**CITY OF PORTLAND, MAINE
DEVELOPMENT REVIEW APPLICATION
PLANNING DEPARTMENT PROCESSING FORM**

RE: RIVER'S EDGE SUBDIVISION, PORTLAND, ME

As requested we have modified the drawings and stormwater calculations in response to the May 1st memo from Jonathan Spencer of the City's Planning Department. Below is a summary of the items that are addressed with this submittal the numbering matches the memo. Items 1 and 2 are being addressed by you or Peter.

RE: River's Edge – Peter Kennedy

Figure 70.1 STONE SIZE FOR RIPRAP (USDA Soil Conservation Service)

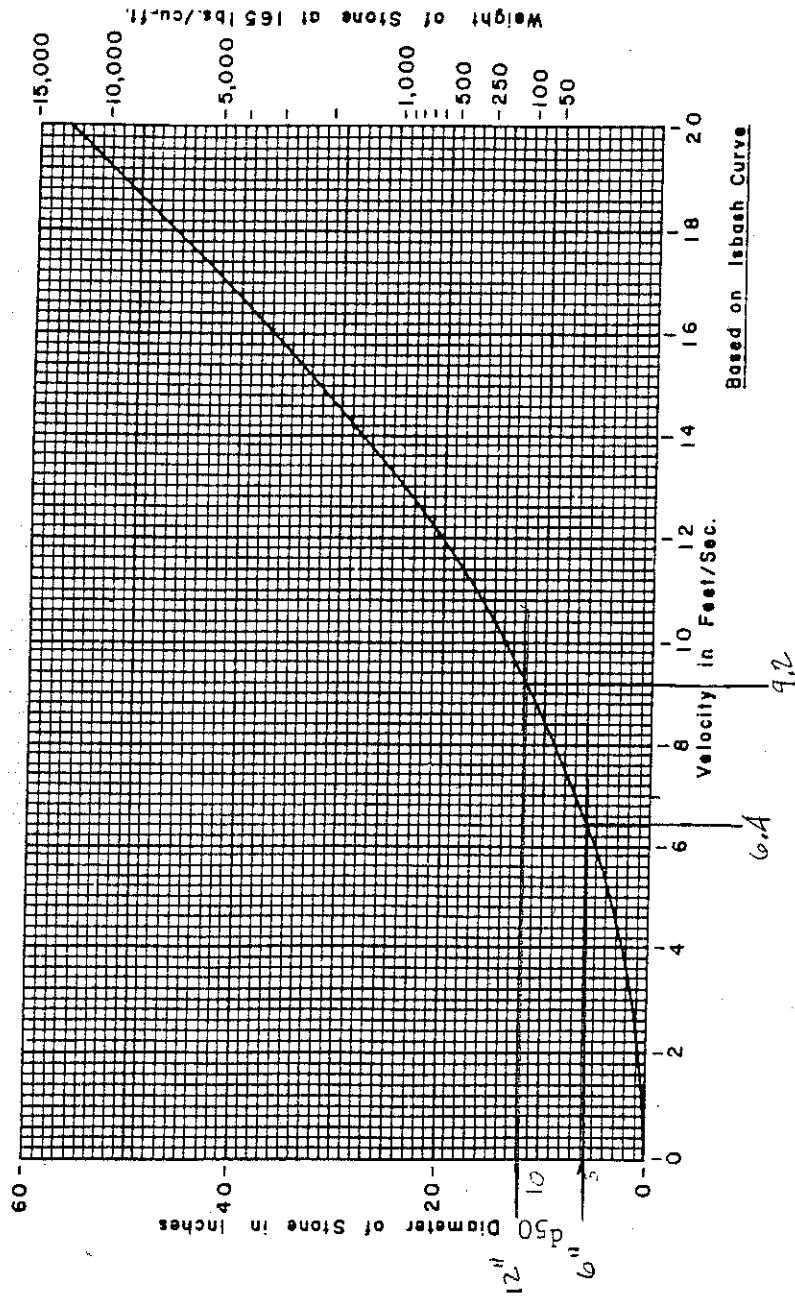
4. Attached are riprap sizing criteria. We have modified the outlets of two culverts to be plunge pools versus aprons.
5. A revised cross section has been provided for the 5' diameter culvert at Station 19+00.

PLANS SHOW $D_{50} = 6''$ EVERYWHERE EXCEPT AT 5' ϕ CULVERT

- 5' ϕ CULVERT HAS 133 CFS IN 25 YR STORM

6" D_{50} IS OK UP TO 6.4 FT/SEC

12" D_{50} IS OK UP TO 9.2 FT/SEC

BASED ON THIS $D_{50} = 6''$ OK EVERYWHERE

$D_{50} = 12''$ OK FOR 5' ϕ CULVERT

Figure 70.1 STONE SIZE FOR RIPRAP (USDA Soil Conservation Service)

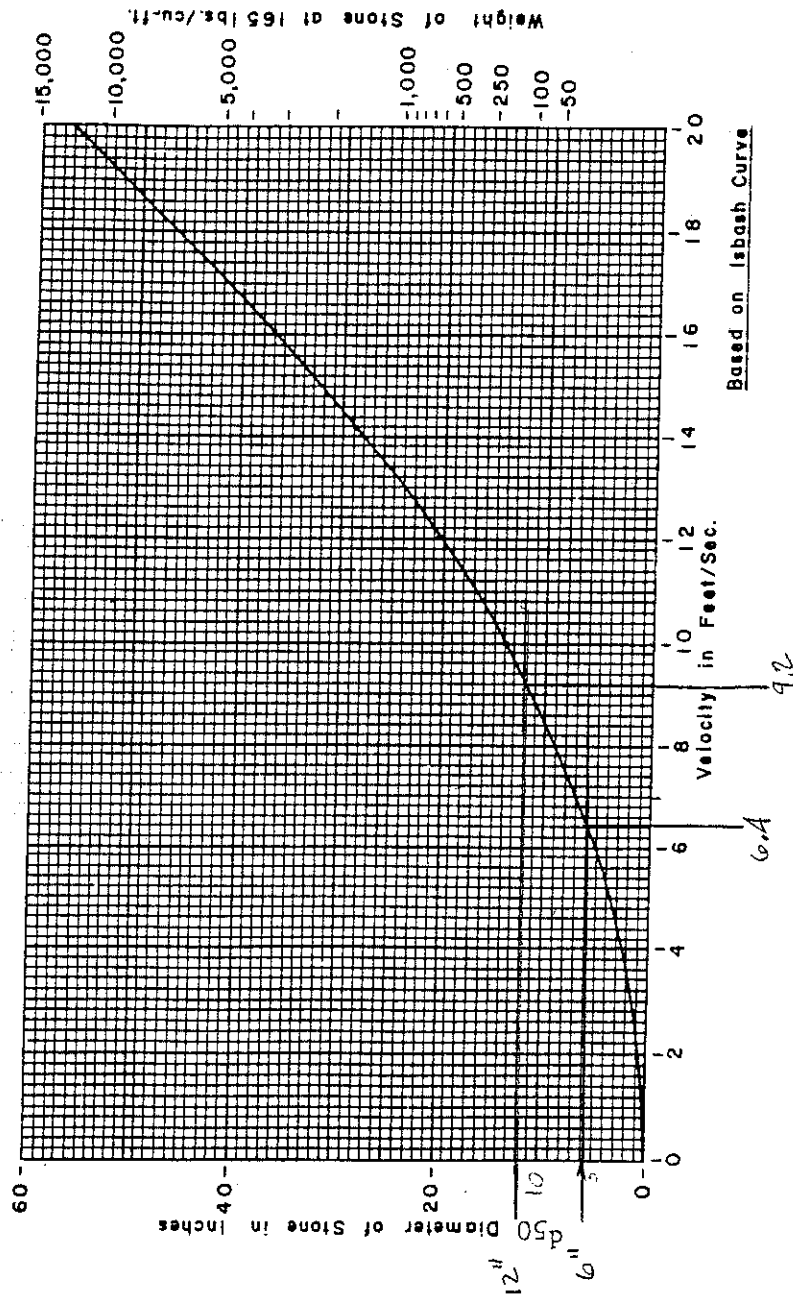
4. Attached are riprap sizing criteria. We have modified the outlets of two culverts to be plunge pools versus aprons.
5. A revised cross section has been provided for the 5' diameter culvert at Station 19+00.

PLANS SHOW $D_{50} = 6''$ EVERYWHERE EXCEPT AT 5' ϕ CULVERT

Figure 70.1 STONE SIZE FOR RIPRAP (USDA Soil Conservation Service)

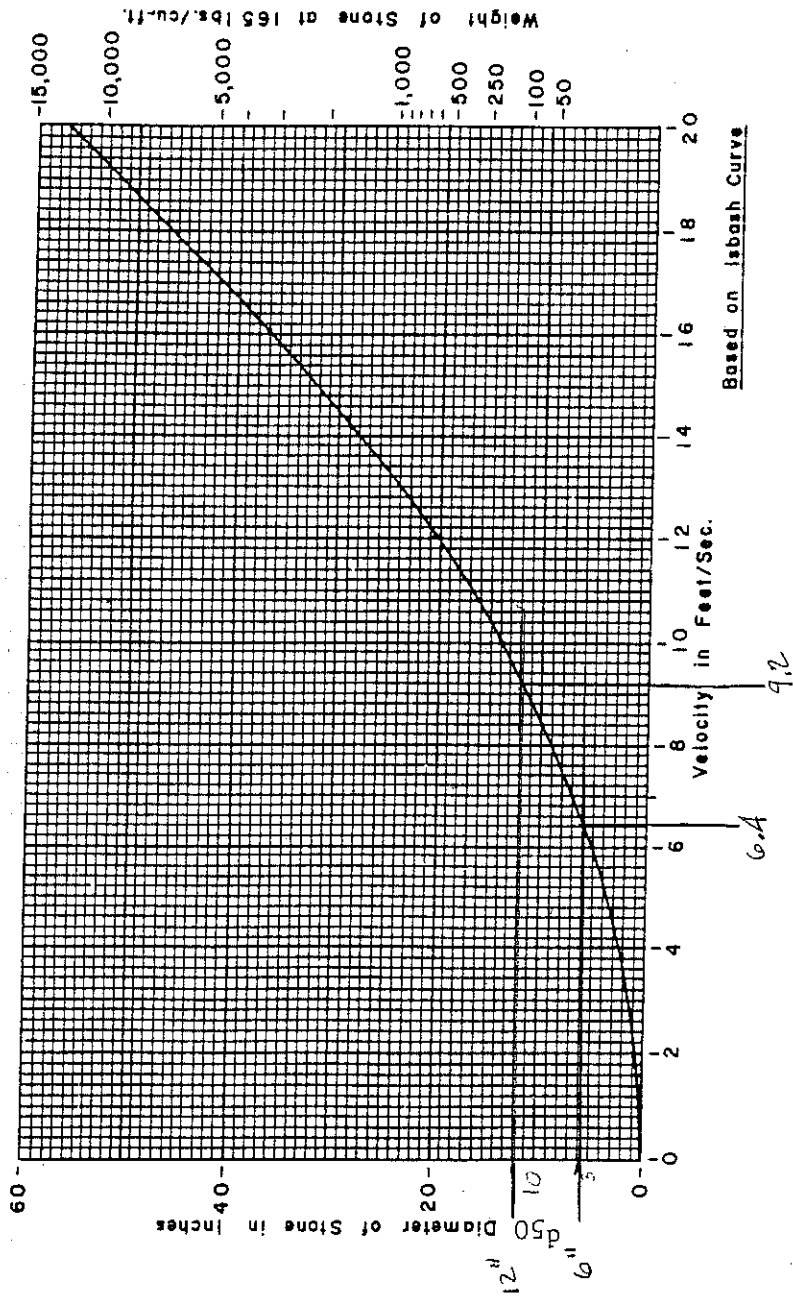
4. Attached are riprap sizing criteria. We have modified the outlets of two culverts to be plunge pools versus aprons.
5. A revised cross section has been provided for the 5' diameter culvert at Station 19+00.

PLANS SHOW $D_{50} = 6''$ EVERYWHERE EXCEPT AT 5' ϕ CULVERT
